February 5, 2018

RESPONSE TO REQUEST FOR INFORMATION (RFI) 1 - 9

The submitted RFI questions are below, followed by the City of Merced's response.

ENGINEERING DEPARTMENT		CITY OF MERCED, CA.	
SEWER LATERAL			S-7
DRAWN: KGE	APPROVED BY: <i>David L. Tucker</i>	DATE: 3/17/08	SHEET OF
DATE: 1/02	CITY ENGINEER		
REVISED: 3/17/08

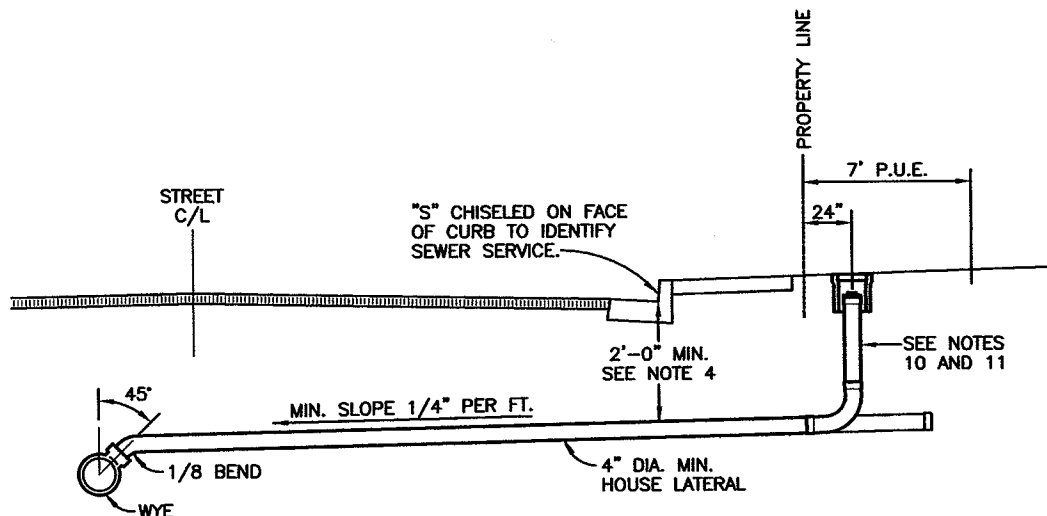
9. *“What type of pipe are the laterals that we are reconnecting to new sewer main or manholes?”*

Response: Per the Project Specifications and City Standard Detail S-7:

Section 10-1.25 “All incoming and out flowing sewer mains or laterals shall be extended and re-connected to the new manhole as required and as shown on the plans, using like materials and C-594 sewer repair couplings with stainless steel shear rings, or an approved alternative method.”

Section 10-1.26 “Connection of the new service lateral to the mainline shall be accomplished by means of a compression-fit service connection. The service connection shall be specifically designed for connection to the sewer main being installed, and shall be INSERTA TEE as manufactured by Fowler Manufacturing Co. Hillsboro, Oregon, (503) 357-2110; or approved equal. Install using procedures and equipment as referenced in manufacturer’s written installation instructions.

This item includes all pipe replacement or extensions, fittings, bends, couplings, trenching, backfill, compaction and paving. The work shall comply with **City Standards S-7** (Sewer Lateral).”

City Standard Detail S-7: See the attached sheet for the full detail.
